<b>TAL-CO SUPPLEMENTAL INSTRUCTION #74</b>			
<b>HOLD OPEN DOORS &amp; REVISED DOOR SWING ON 4TH LOBBY</b>			
Project Name:	<b>RW TOMLINSON - NEW HEAD OFFICE</b>		
Project Location:	<b>100 CitiGate Drive, Ottawa, Ontario</b>		
ARCH. SI #:	<b>ASK 213</b>	Issued By:	<b>Farah Bano</b>
STRUC. SI #:	<b>N/A</b>	Date Issued:	<b>December 14, 2017</b>
MECH. SI #:	<b>N/A</b>	Revision #:	<b>N/A</b>
ELEC. SI #:	<b>CCN E20</b>	Revision Date:	<b>N/A</b>

**TITLE: HOLD OPEN DOORS & REVISED DOOR SWING ON 4TH LOBBY**

CCN E-20

DATE:	12/11/2017
SCALE:	1:100
DRAWN BY:	JK
JOB No.:	574-15
DRAWING No.:	<b>ASK-213</b>

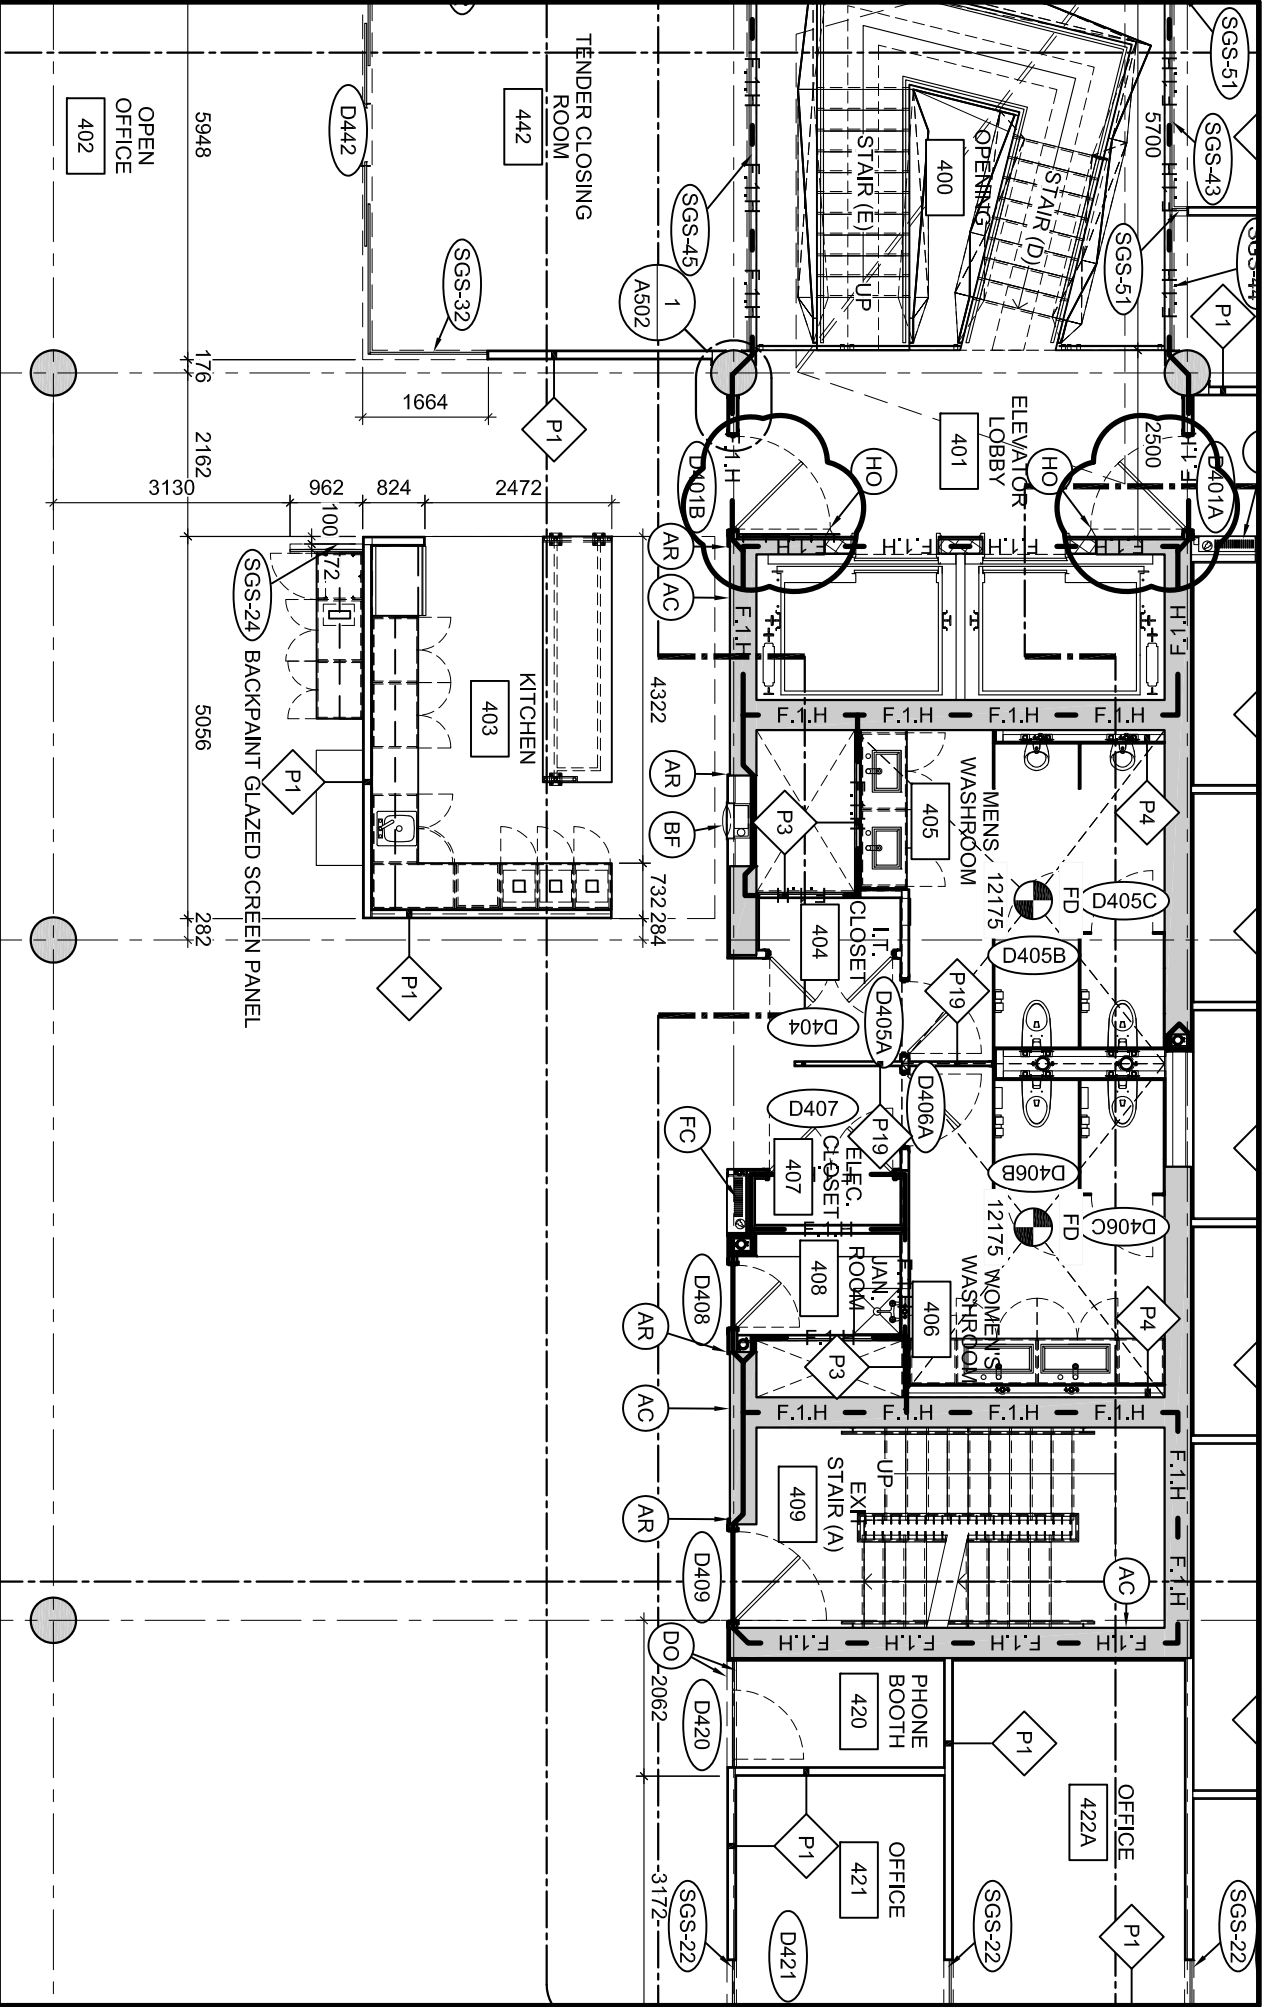
- Provide Door Hold Open Devices at doors D112, D401A & D401B as per CCN E20.
- Revised Door swing at elevator lobby 401 - Affects existing door and frame.

- CCN E20 - To coordinate electrical with architectural door details.
- ASK 213 - To improve function, and to avoid interference with fire hose cabinet.

**Provide required electrical for change in door swing (architectural ASK-213.**

1. Provide door hold open devices for doors D112, D401A and D401B. Door hold open devices to be tied in F/A and release on alarm.
